PROPOSAL: Bungalow + Septic Tank + Domestic Gate Lodge

LOCATION: Laurel Hill, Stocking Lane

Register Reference : 91A/1778

Development : Construct a bungalow, septic tank and new entrance  
gates and to remove existing derelict gate lodge

Drawing: REVISED SITE PLAN  
Drawing n° 91/25/17  
Scale: As noted

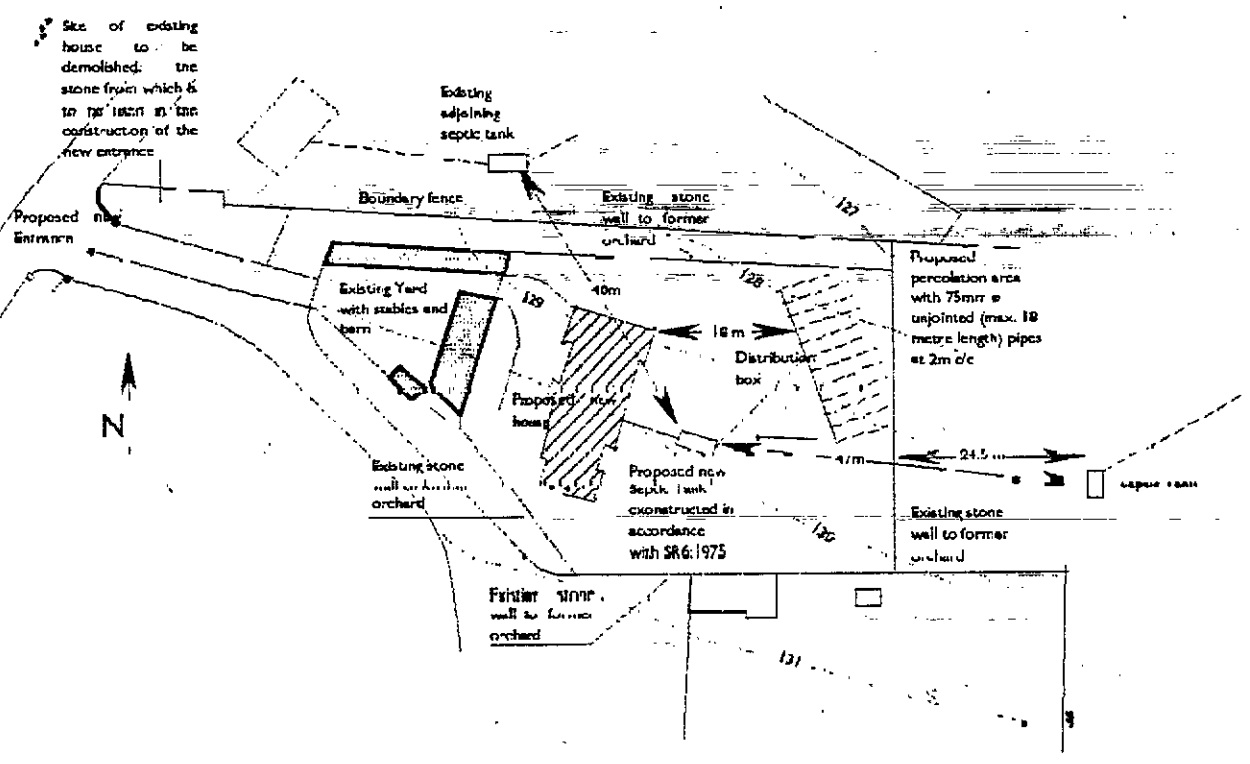
On Monday 6<sup>th</sup> and Tuesday 7<sup>th</sup> January 1992 I supervised two percolation tests on the above site. Percolation test holes were located in the percolation area as shown in the revised plan (copy attached). Both percolation tests failed. Indeed the level of water had increased in one of the test holes.

These revised proposals are unacceptable to this section as the soil is unsuitable for the treatment & disposal of septic tank effluent.

Drawing: REVISED SITE PLAN  
Drawing n<sup>o</sup>. 91/25/17  
Scale: As noted

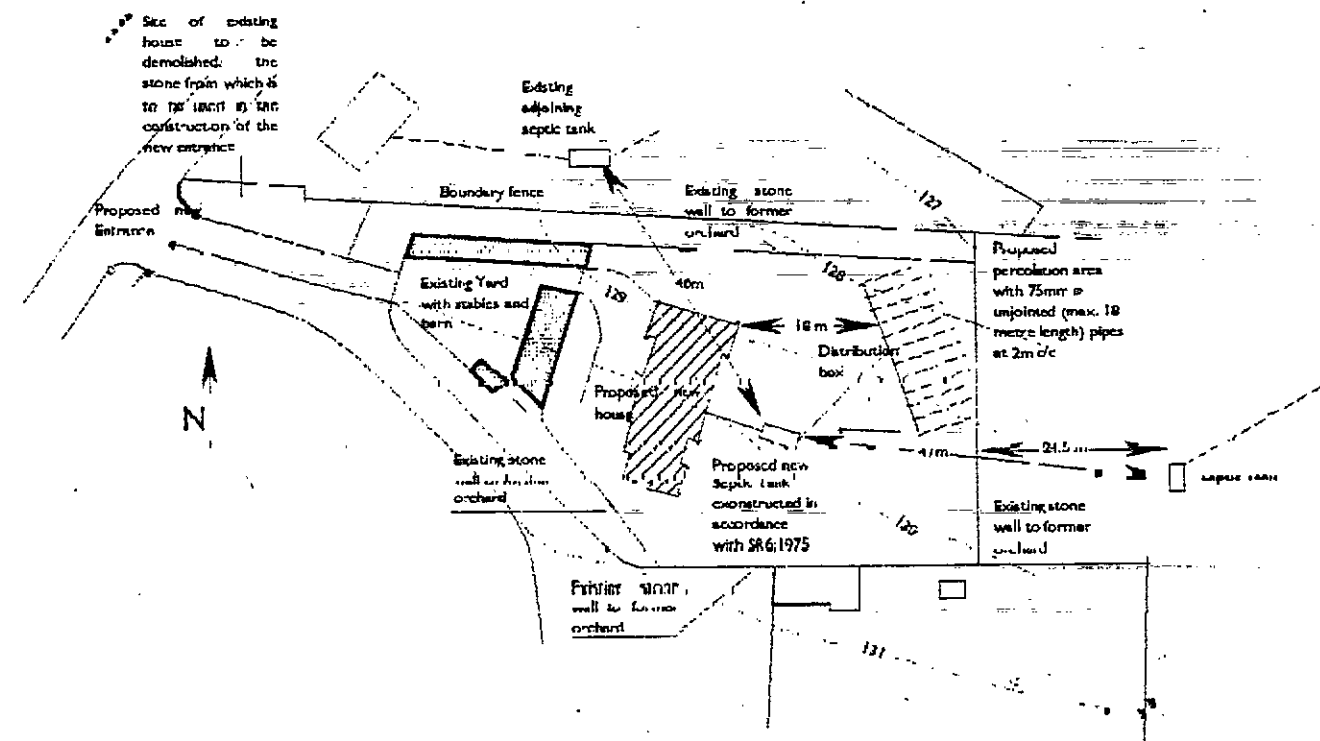
On Monday 6<sup>th</sup> and Tuesday 7<sup>th</sup> January 1992 I supervised two percolation tests on the above site. Percolation test holes were located in the percolation area as shown in the revised plan (copy attached). Both percolation tests failed. Indeed the level of water had increased in one of the test holes.

These revised proposals are unacceptable to this section as the soil is unsuitable for the treatment & disposal of septic tank effluent.
